Development Management – Delegated Officer Report

Application Number:	AWDM/0228/26	Recommendation - Approval
Site:	Former Mannings, Surrey Street, Shoreham-by-Sea, West Sussex	
Proposal:	Application for a Non-Material Amendment following approval AWDM/1281/19. Amendments: 1, Introduction of vents on the North and West elevations and adjustments of louvres to external doors; 2. Introduction of a cooling unit on the fifth-floor maintenance roof required in connection with UPS room at GF level in connection with the introduction of two smoke shafts within the building to comply with the fire strategy; 3. Adjustments to GF landscaping and coordination of levels to comply with the fire strategy and Building Regulation requirements; 4. Revised material schedule accounting for alternative use of glazed tiles to entrance areas; 5. Introduction of brick piers/walls at ground and first floor level to southern elevation and ground to third floor levels at western elevation to support fire rated brick screens to inset balconies; 6. Revised vehicle entrance gate design;

Figure 3 - Proposed partially louvered openings (northern elevation)

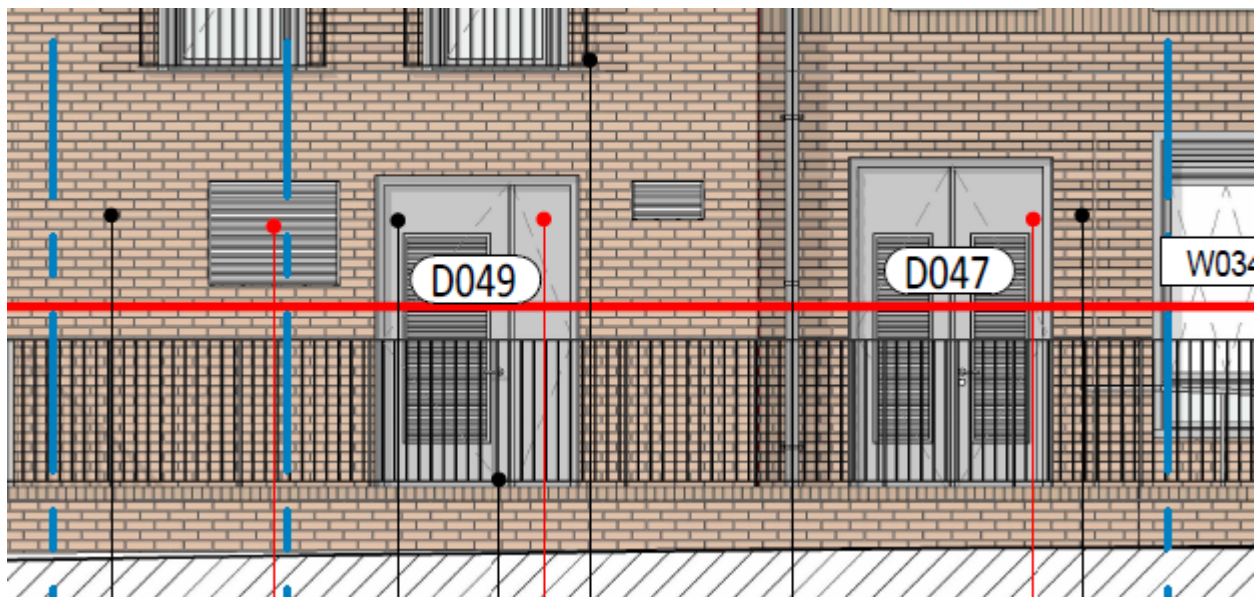
The openings now proposed feature partial louvres with a larger solid component, as shown at **Figure 3** below. The arrangement for door 'D047' as shown at **Figure 3** below should be noted as consistent with all openings featured to the southern elevation of the building.

This change is considered to represent a negligible visual change in the context of a development of the approved scale. Both as previously approved and now proposed doors to service spaces would possess a utilitarian character expected of openings to service/plant spaces. Officers do not consider that this proposed change would materially diminish the design quality of the approved development or otherwise influence compliance with the requirements of Policy 15 to the Adur Local Plan (ALP) (2017), insofar as this policy demands development of high quality design sympathetic to the character of its respective setting.

Figure 4 - Ground Floor Layout (submitted plan)

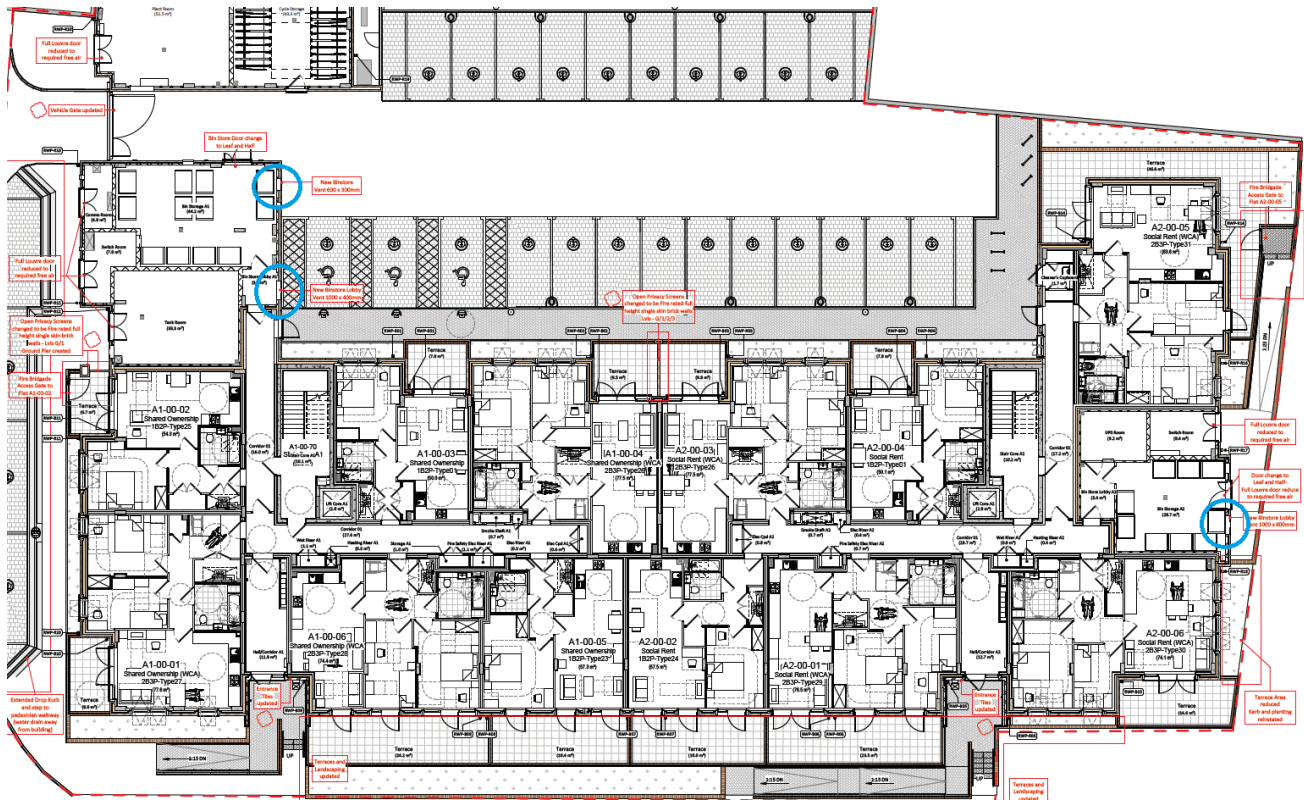
Three total additional vents are proposed to refuse stores, the positions of which are highlighted in **Figure 4** below (in blue). 2x vents would be introduced to the northern elevation facing onto an internal car-park with a single vent introduced to the northern elevation facing onto Ham Street.

Figure 5 - Proposed vent to refuse store (northern elevation).

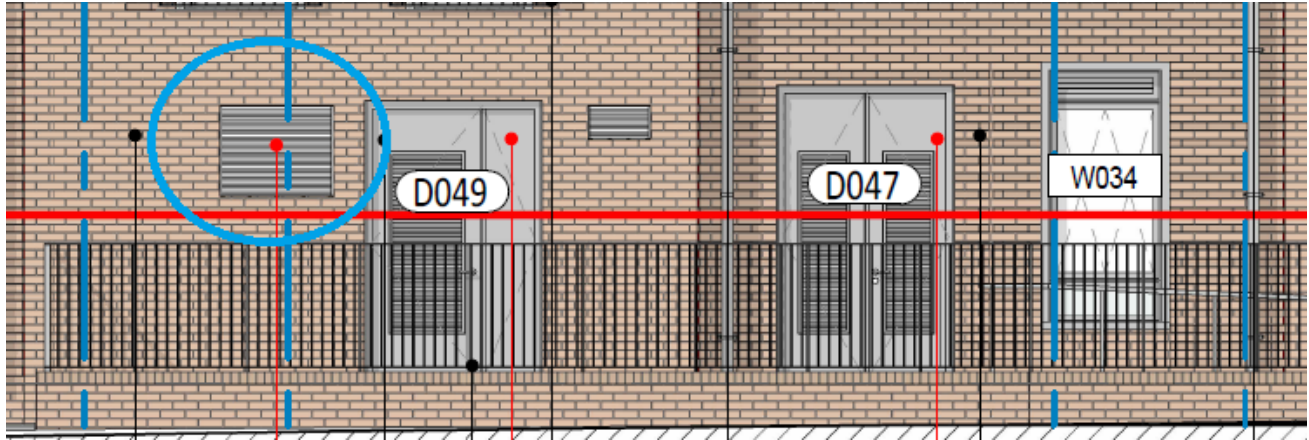
Plans submitted in support of the proposed development show these vents to be medium size and of louvered composition. That featured to the northern elevation, consistent with all proposed vents, is shown at **Figure 5** below as highlighted in blue. The submitted material schedule confirms that this would be comprised of metal finished in a matching gray to match windows, doors, balcony balustrading and railings.

The introduction of additional openings to the proposed building is considered to marginally add to a perception of visual clutter relative to the building in its approved state. The number of additional openings, however, is very limited (3x total) with 2x such openings opening onto an internal courtyard such that these would not be visible within the public realm. It is considered that these openings, of matching colour and finish to similar components, would likely have been deemed acceptable to officers if presented as a component of the original scheme. These additions, therefore, are considered acceptable in relation to the requirements of Policy 15 to the ALP in terms of their resultant visual effect.

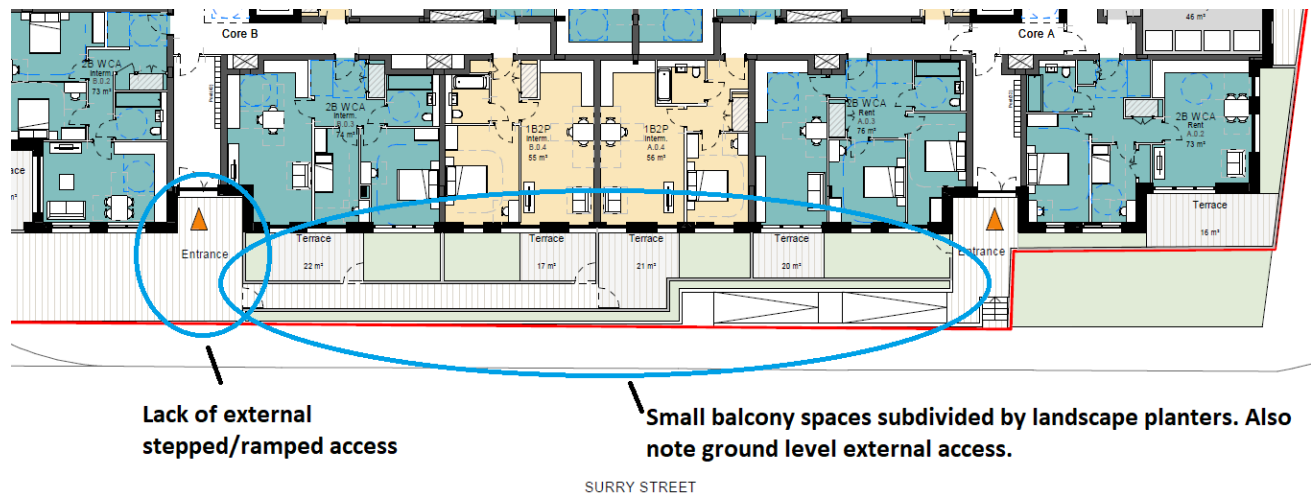
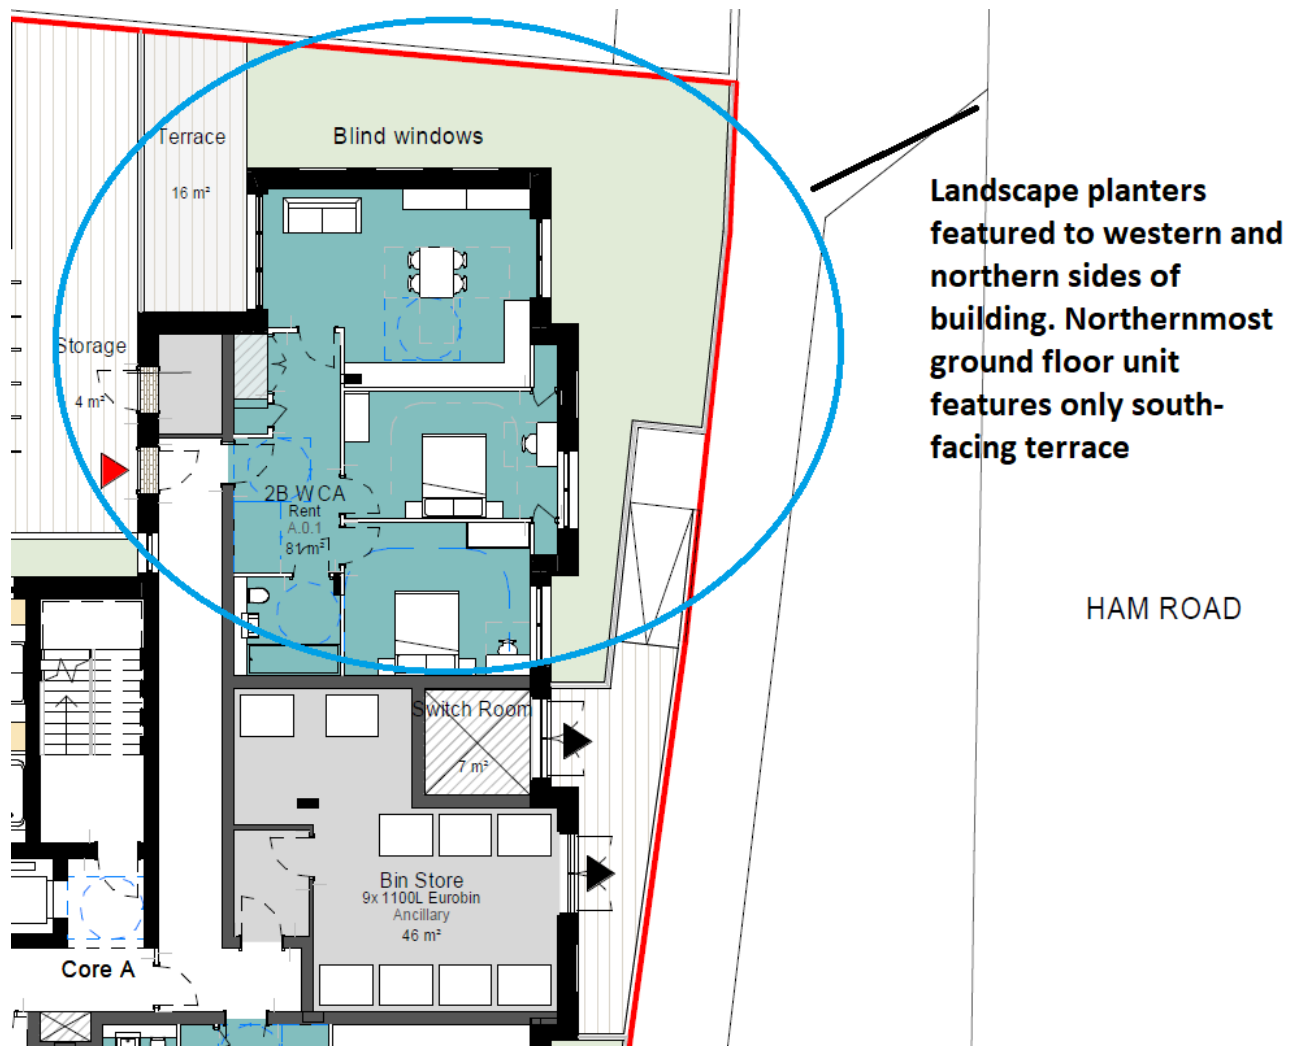
Ground floor terrace spaces were shown to be subdivided by planters with units A1-00-06, A1-00-05 and A2-00-02 (eastern elevation) shown to be serviced by a secondary ground level external access leading from the south. Unit A2-00-05 (northern elevation) was shown to possess only a small south-facing terrace fronting onto the internal car-park.

The originally approved development, further, lacked an external access stair/ramp leading to Core B of the building.

The originally approved ground-floor layout are shown at **Figures 6 and 7** below, with features noted above highlighted for ease of reference.

Figure 8 - Described arrangement of east-facing ground floor units

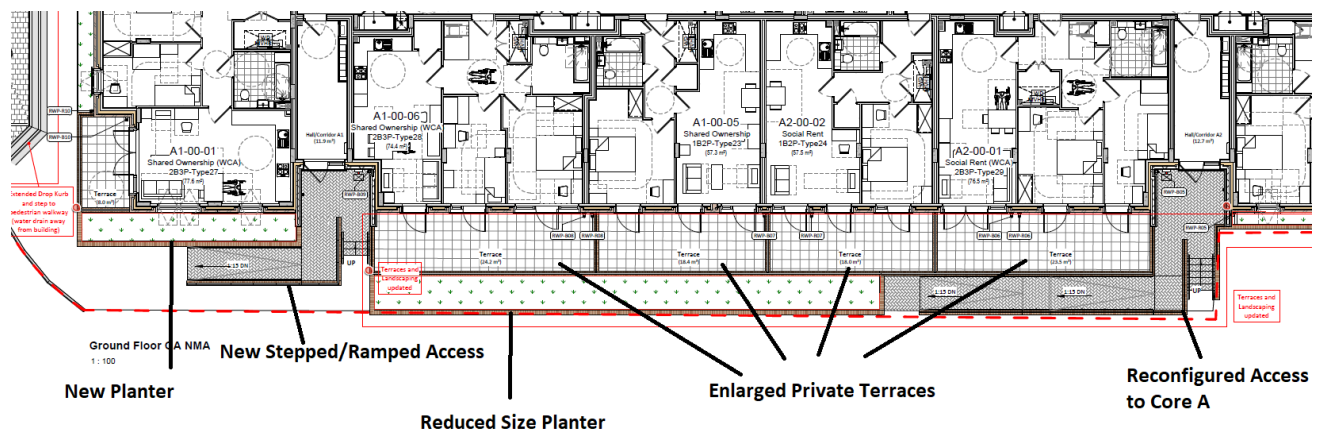
The submitted plans, further, describe the loss of a secondary ground-level external access to units A1-00-06, A1-00-05 and A2-00-02 and the instatement of an external/stepped ramped access to Core B. Planters would be provided forward of units A1-00-06, A1-00-05 and A2-00-02 with a new planter introduced to the side of unit A1-00-01. The approved stepped/ramped access to Core A would be reconfigured in order to accommodate terraces of increased scale to units A2-00-01 and A2-00-02. The reconfigured arrangement is shown (with annotations) at **Figure 8** below.

Notwithstanding the exact rationale for the amendments described on the submitted plans, these various changes would represent a notable divergence from the approved scheme and its expected relationship with both Ham Road and Surry Street at ground level. The reduced scale and extent of planters reduces opportunities for the introduction of larger structure planting and would leave parts of the main street frontages unrelieved by soft-landscaping. The addition of planting to the east of unit A1-00-01 is not considered to satisfactorily compensate for the loss of soft-landscaping opportunity elsewhere.

The addition of a planning condition requiring the submission and approval of details of privacy screens to east-facing ground floor terraces, however, is recommended to allow a degree of control over the design and quality of these components and recognising that their future introduction is effectively inevitable given the proximity and arrangement of approved terrace spaces.

Figure 9 - Described arrangement of north-facing ground floor units

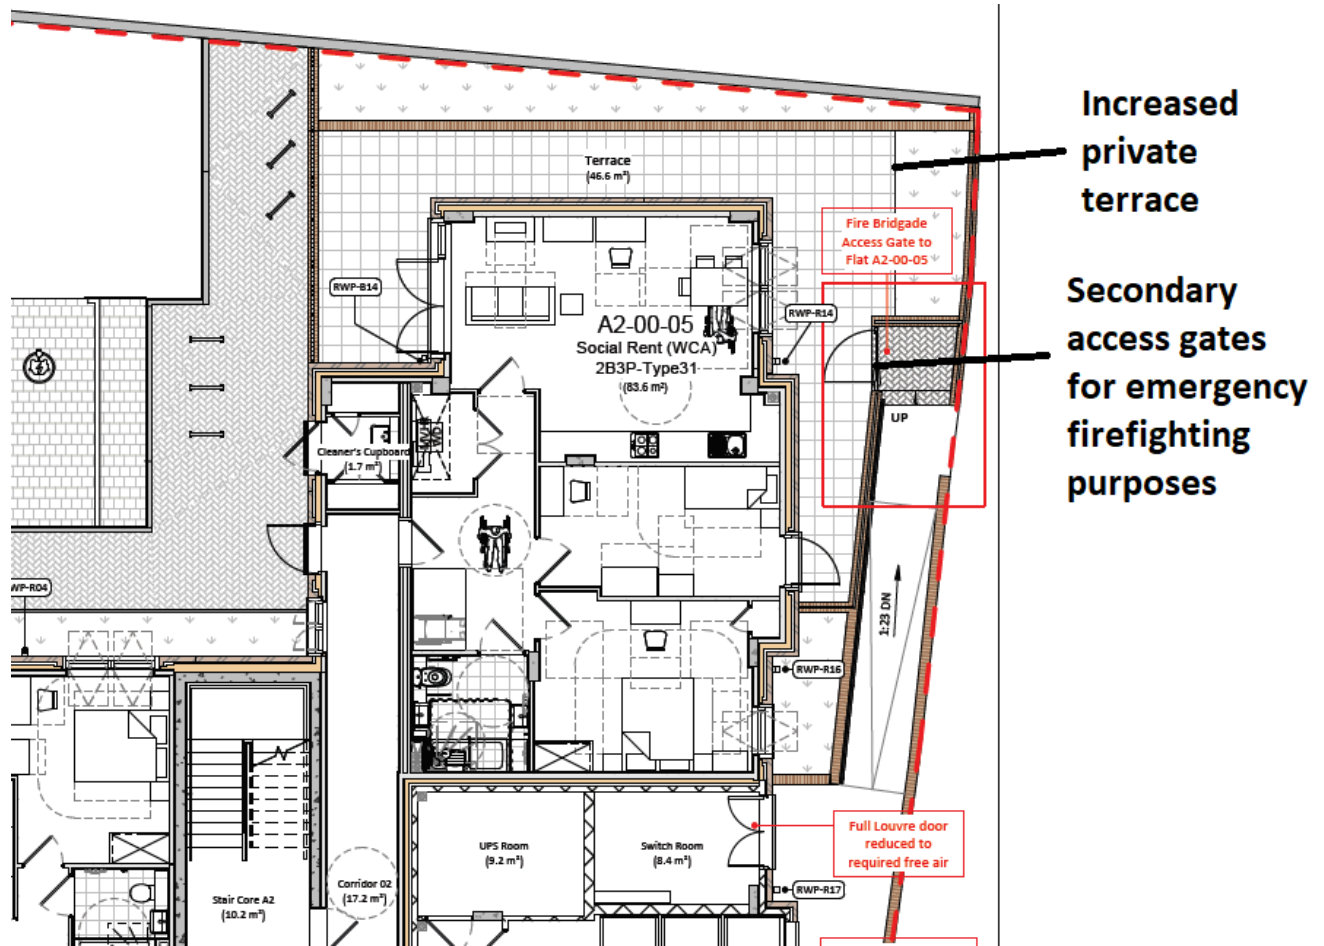
The reconfigured arrangement for the north facing unit is shown at **Figure 9** below. Of note is the greatly increased private terrace serving unit A2-00-05 and the introduction of a secondary (external) ramp leading to this unit for fire fighting purposes.

Further, while the introduction of railings/balustrade to raised terraces of this nature is somewhat expected, this addition does add to a perception of clutter at street level and reduces the visual simplicity of the buildings eastern and northern elevations as originally illustrated on the approved plans. The arrangement described on the submitted plans, further, is likely to be rendered more complicated by a future requirement/desire to introduce a privacy screen to east external terraces to ground floor terraces associated with units A1-00-06, A1-00-05, A2-00-02 and A2-00-01 given their directly adjacent arrangement and the absence of any separating feature shown on the submitted plans at present.

Figure 10 - Described arrangement of eastern elevation (excerpt) (submitted plan)

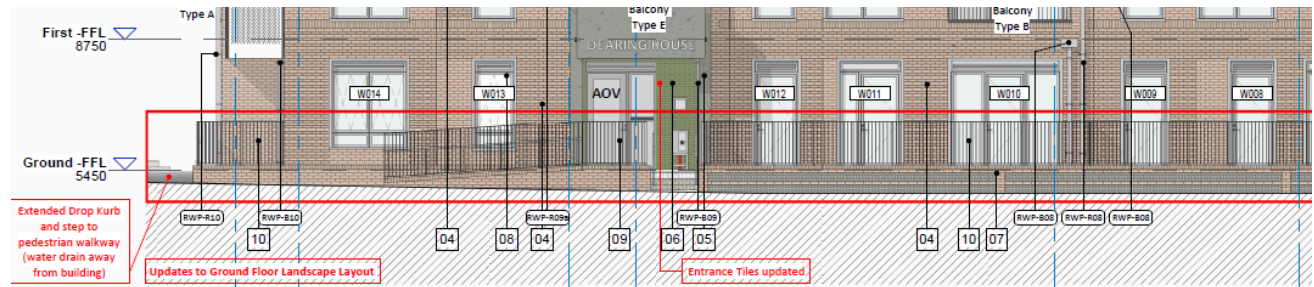
In visual terms the submitted elevations describe the ground floor terraces/ramps to be constructed of a brick plinth matching the main elevations of the building also featuring light-grey metal balustrade/railings consistent with the colouring/finishing of balconies, doors and windows. This arrangement is shown in the (excerpted) eastern elevation included below (**Figure 10**).

Figure 12 - Approved ground floor layout (ref: AWDM/1284/25).

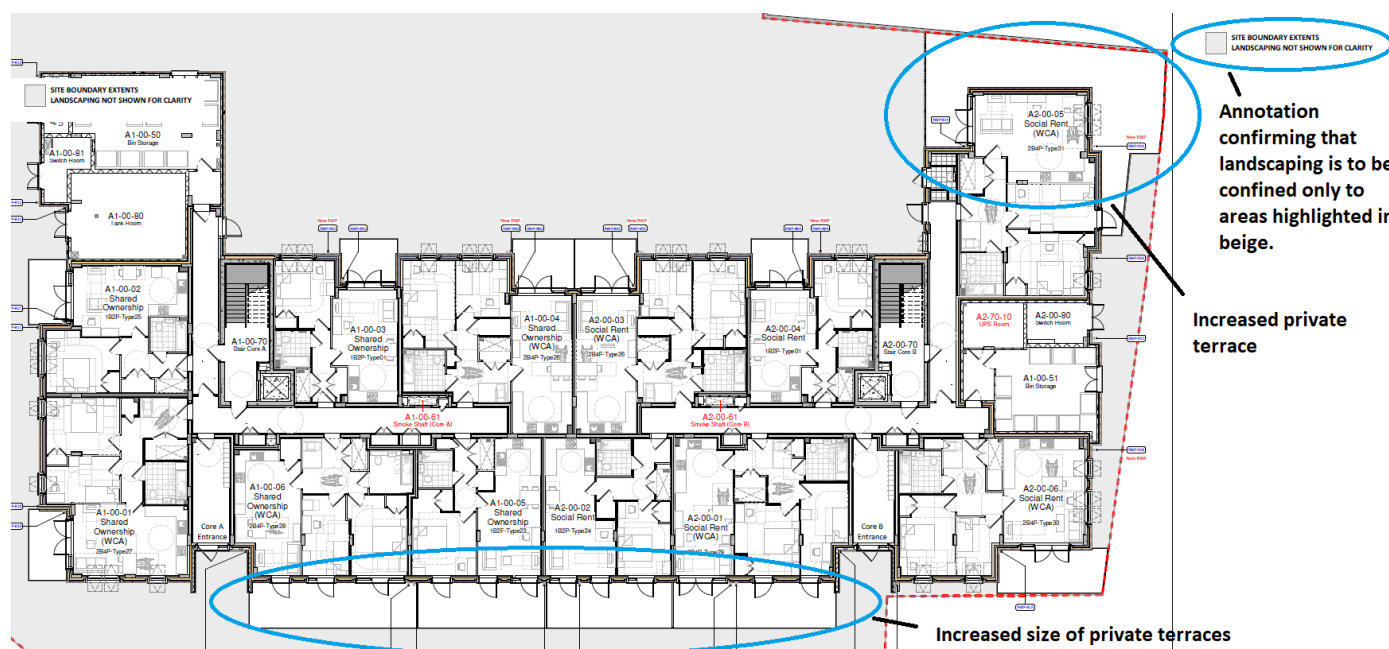
It is, however, of direct and significant applicability to the consideration of this amendment, as now described, that plans previously approved pursuant to ref: AWDM/1284/25 describe precisely the same arrangement of planters, pedestrian accesses and railings as now shown.

Plan ref: P646-CAL-ZZ-GF-GA-A-208 Rev PL01 (as approved pursuant to ref: AWDM/1284/25) shows the increased ground floor terraces to units positioned on the respective eastern and northern elevations of the building. An annotation included on the plan, further, confirms that landscaping was to be confined only to areas shaded beige on the plan. The approved ground floor layout is shown at **Figure 12** below.

Figure 14 - Approved eastern elevation (ref: AWD/1284/25).

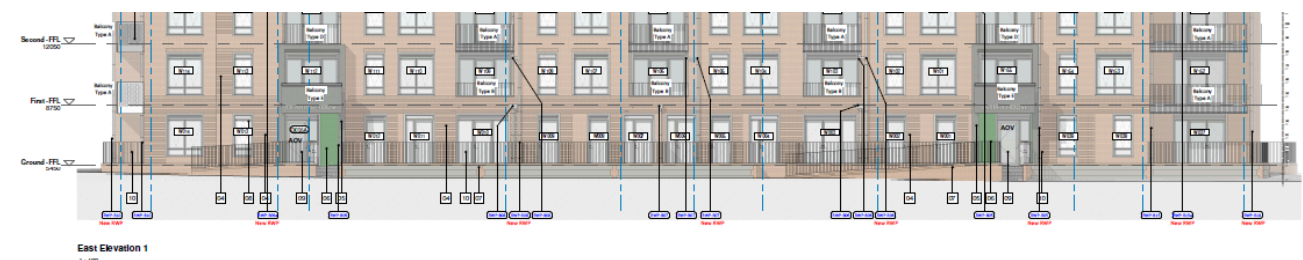
The eastern (ref: P646-CAL-ZZ-ZZ-EL-A-0313 Rev PL01) and northern (ref: P646-CAL-ZZ-ZZ-EL-A-0310 Rev PL01) approved pursuant to ref: AWD/1284/25 describe exactly the same arrangement to that now depicted, absent the firefighting gates featured to the northern elevation. The approved arrangement is shown in **Figures 13 and 14** below.

Figure 15 - Southern Elevation (submitted plan)

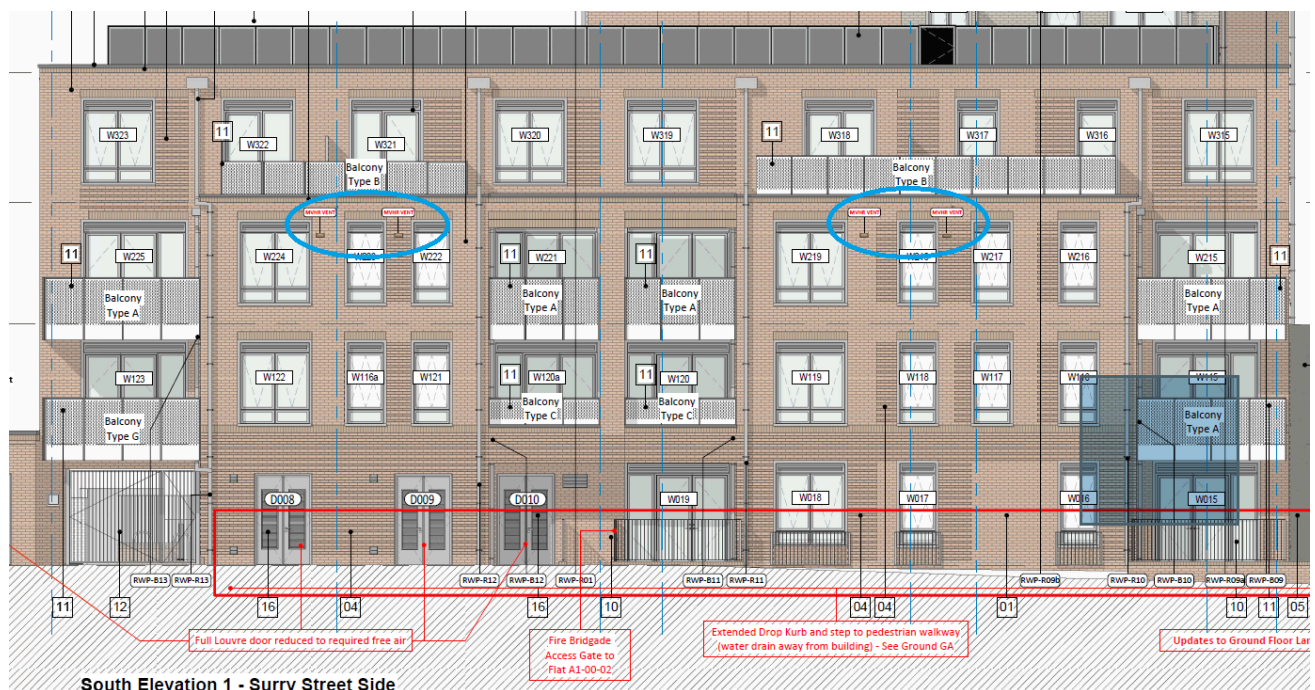
The submitted plans describe the addition of 4x total Mechanical Ventilation Vents at third storey level to the southern elevation of the approved building as highlighted at **Figure 15** below in blue.

The proposed vents are very small and positioned at some height. These, further, are featured to a less visually sensitive elevation and set some distance rear of public viewpoints on Surry Street. The addition of these vents is not considered detrimental to the
